Local Review Body

Continued Planning Application for Review

**Erection of two 67m high to blade tip wind turbines:
Priestside Farm, Auchentiber Road, Kilmacolm (13/0036/IC)**

DEVELOPMENT AT HIGH MATHERNOCK - CONNELL
2 PROPOSED TURBINES AT PRIESTSIDE - DUNLOP

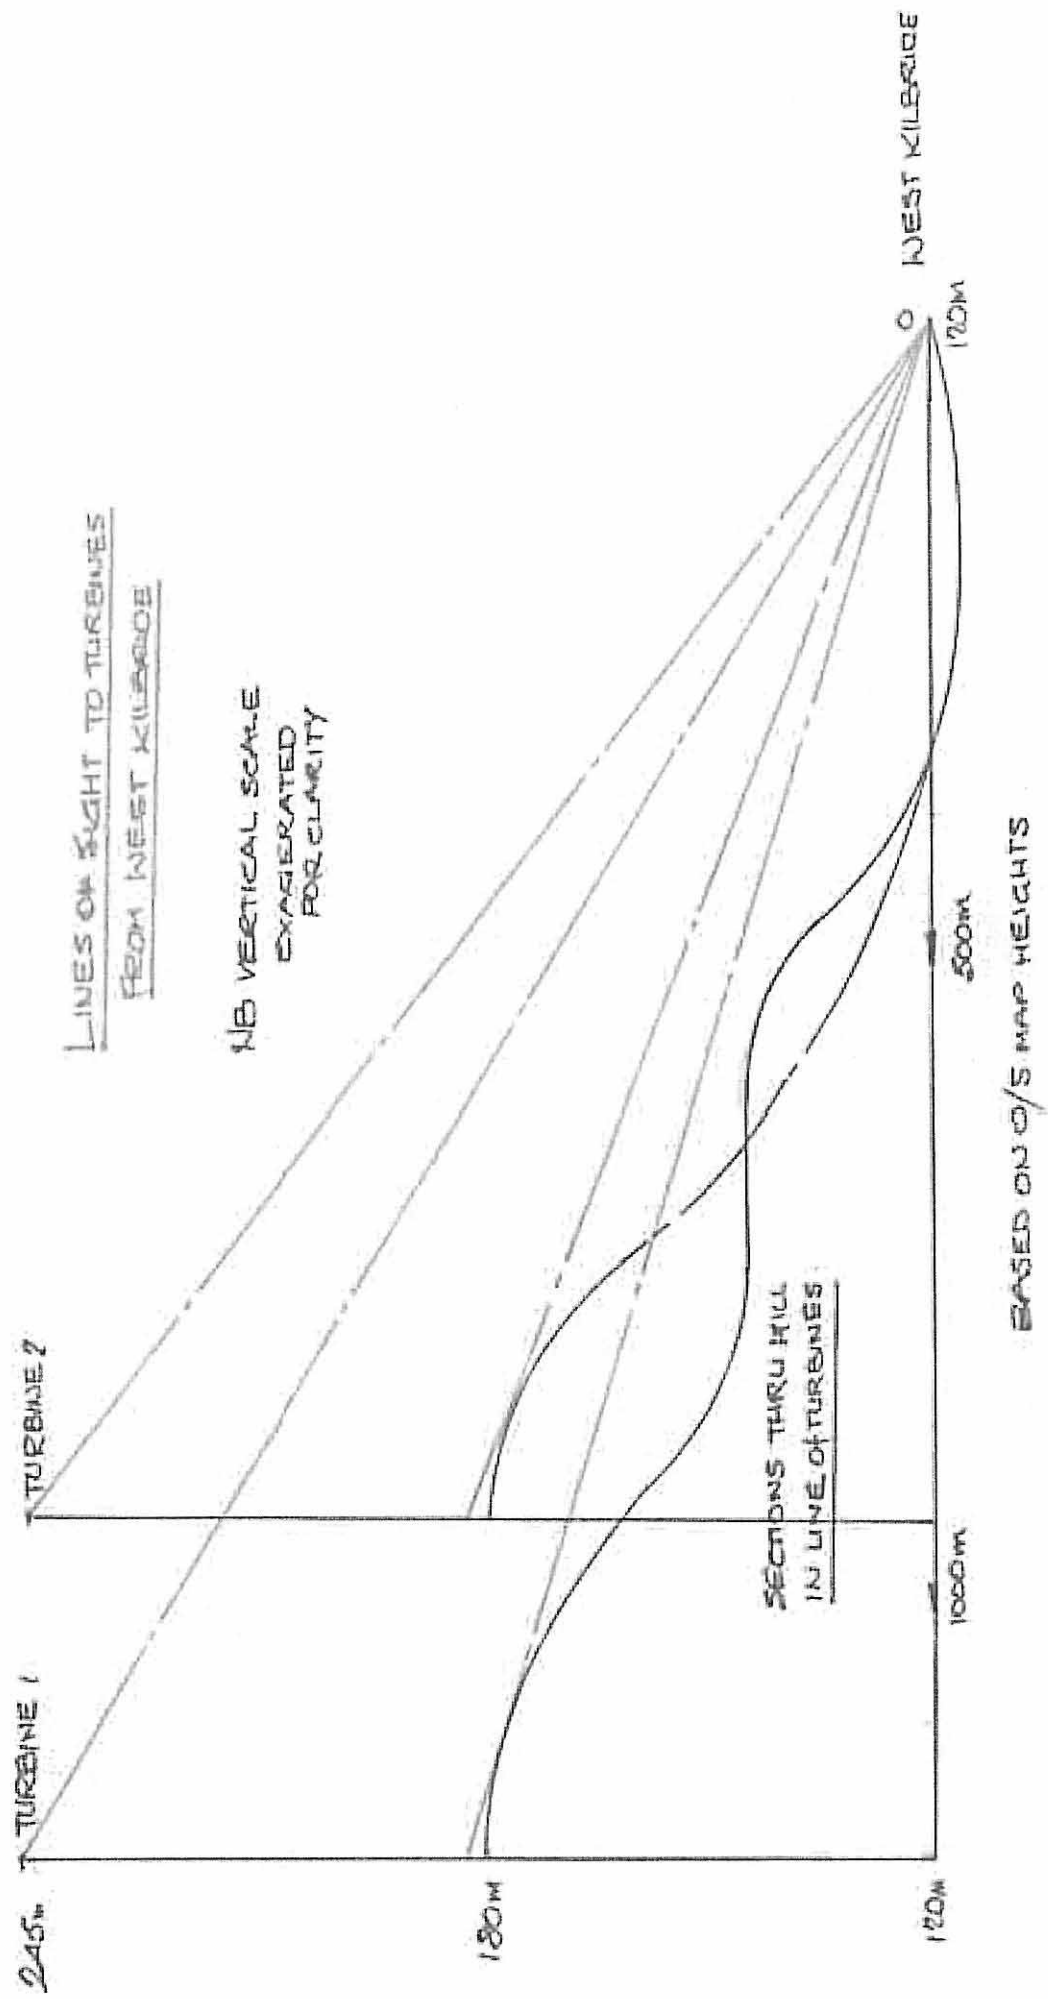
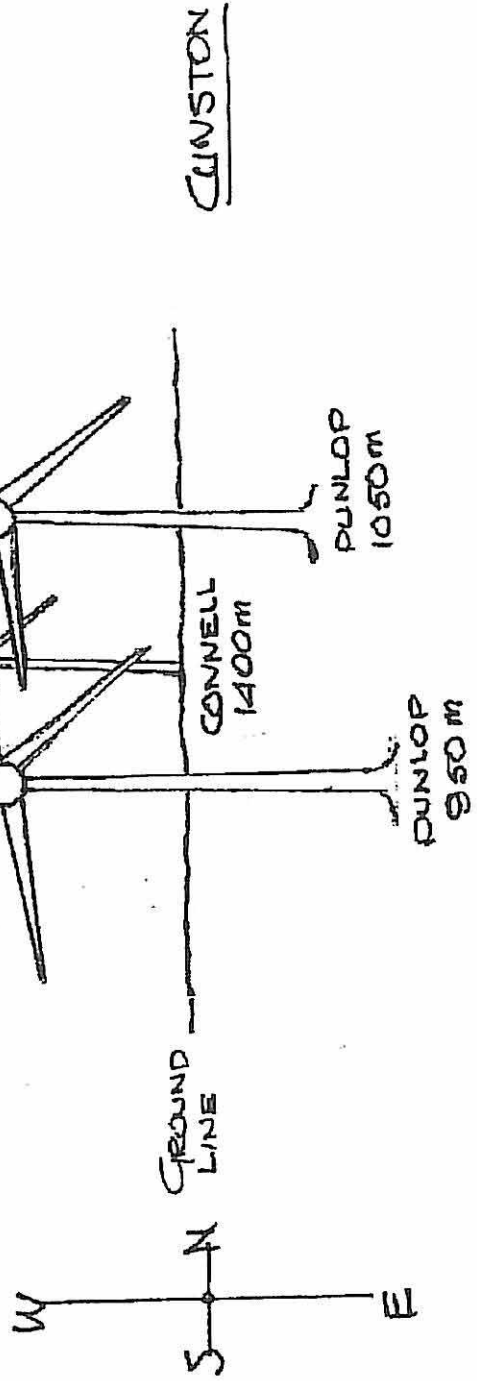
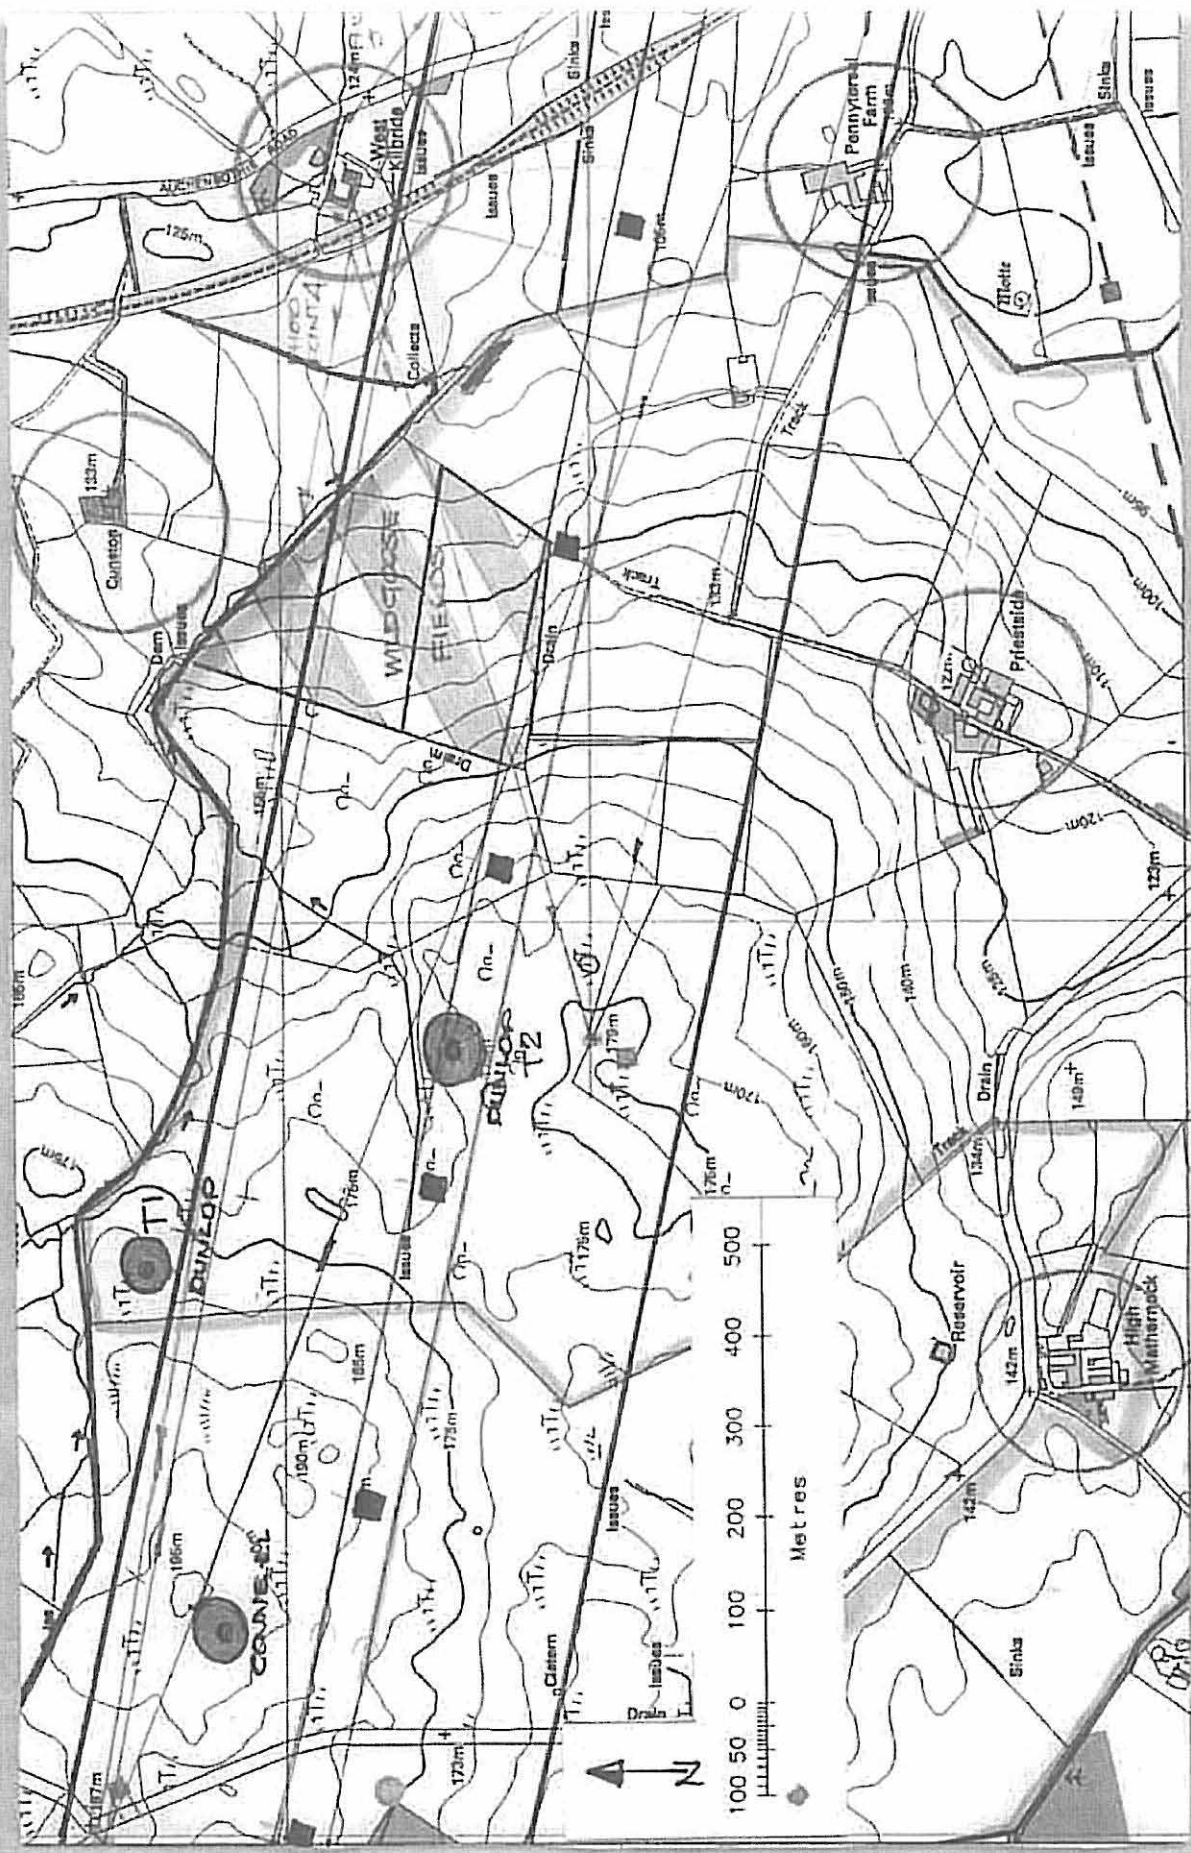
Para 6.26 West Kilbride will experience a **HIGH** magnitude of change. This is extremely concerning. The proposed turbines including the one at High Mathernock will dominate the skyline, and create noise and flicker which will be most disturbing. (see sketch 2)

The Proposal for two further 65m turbines is an unmitigated disaster for the residents of West Kilbride and Cunston Cottage. It has been noted that the Beveridge family has resided at West Kilbride for forty years; the Emerson Family of Cunston Cottage has resided there for several generations. It is strongly recommended that this proposal be refused.
